## **REMARKS/ARGUMENTS**

### **II. Drawings**

FIG. 1 (PRIOR ART)

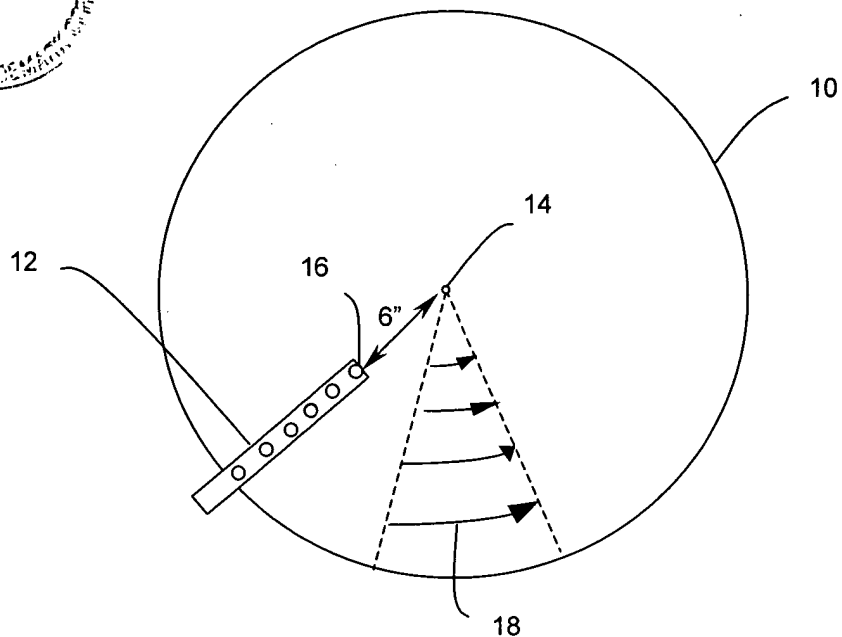
In the subject Office Action, the Examiner objected to FIGS. 1 and 2 not being labeled as being prior art. As shown in the Annotated Sheets for FIGS. 1 and 2, the Replacement Sheets for FIGS. 1 and 2 now include the label "PRIOR ART".

FIG. 3

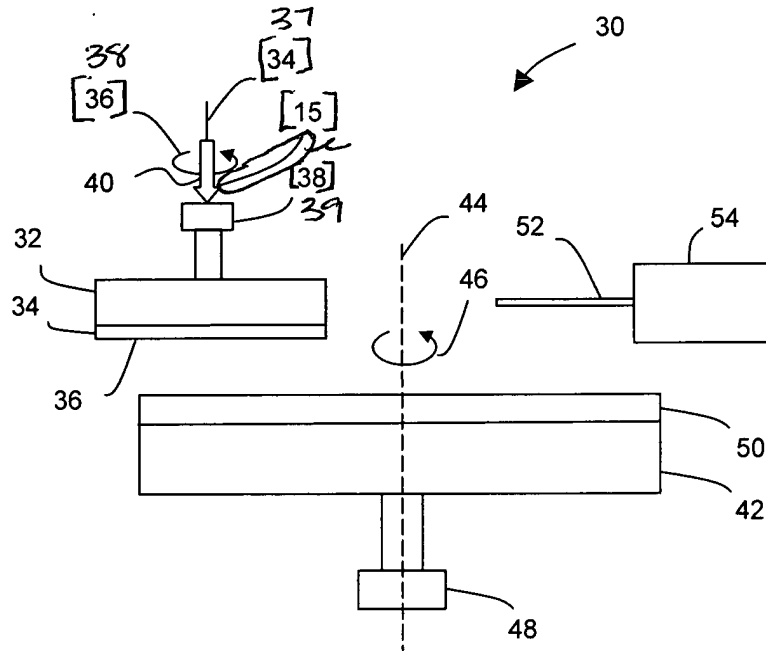
In FIG. 3, the Examiner objected to the use of reference character "34" for both the wafer and the axis. The axis has been relabeled with a reference character 37. The Examiner objected to the use of reference character "36" for both the surface and the arrow. The arrow has been relabeled with a reference character 38. The "motor 38" has been relabeled as "motor 39". Additionally, reference character "15" was removed. Annotated sheets showing changes and replacement sheets are attached to the end of this response.

Due to the changes to the drawings described above, in paragraph 0018, the "axis 34" has been changed to "axis 37", the "arrow 36" has been changed to "arrow 37" and the "motor 38" has been changed to the "motor 39".
